ADDENDUM 002

project	Provo SD Centennial Middle School Security Upgrade	project no	18375.00
date	2018-12-14	no. pages	3
owner	Provo School District		
contractor			
bid date	2018-12-18	bid time	2:00 pm

A2 **ALUM. DOOR HEAD & JAMB DETAIL**

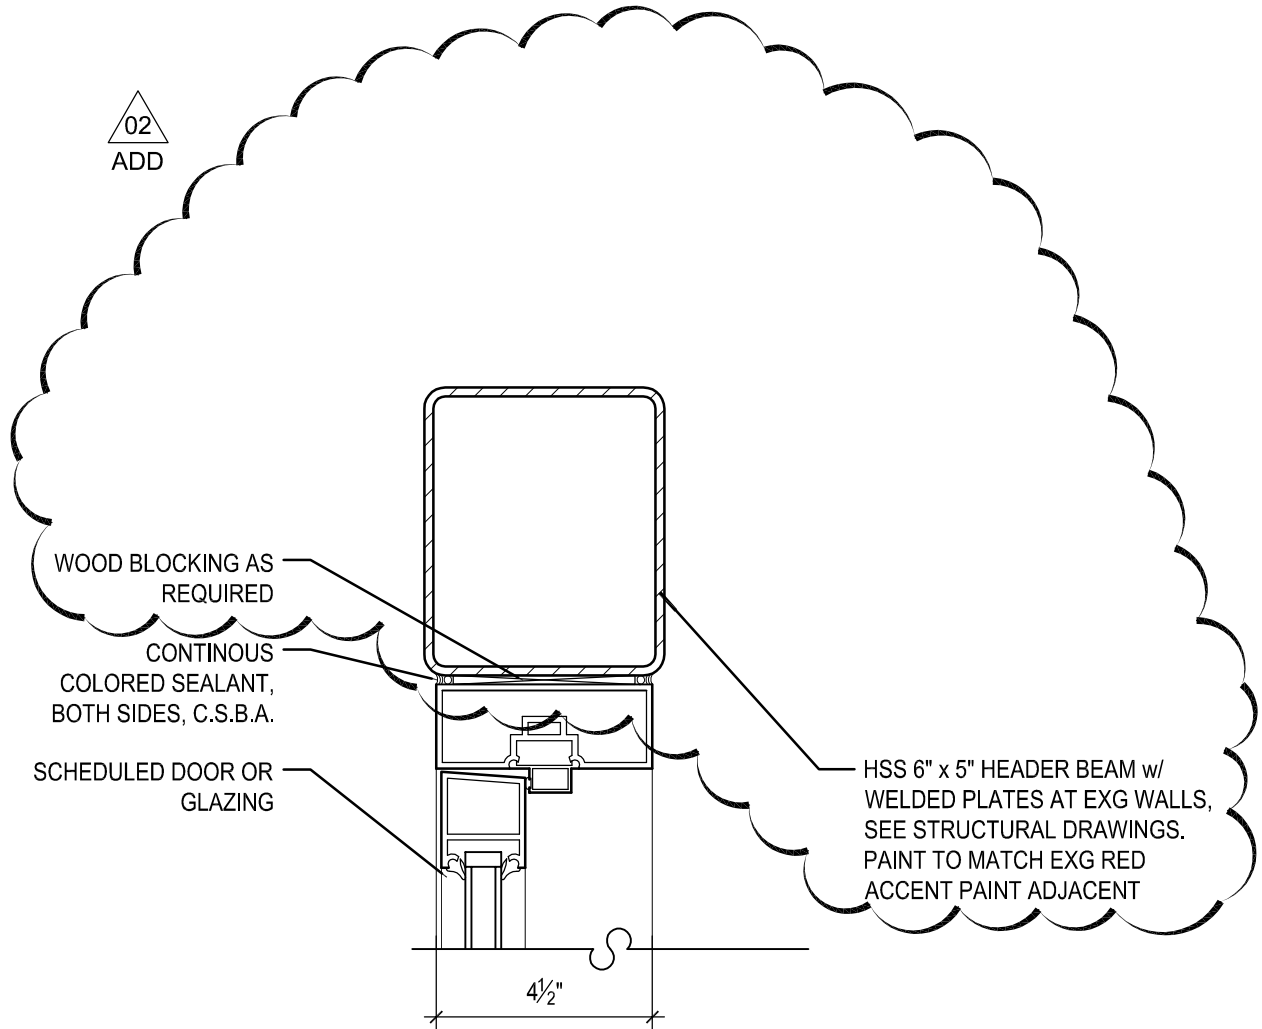
item	sheet#	description
2.1	A101	- Change door CM104 material to HM and hardware set to be 01 . Eliminate keynote 16A for card reader. - Replace detail A2/A101 with the attached.
2.2	A201	<u>Door hardware Set 01</u> - Add to the list of hardware: <i>Power Supply By Div 28 B/O</i>
2.3	EY101	See the attached sheet EY101 from Envision Engineers, removing the card reader from door CM104.
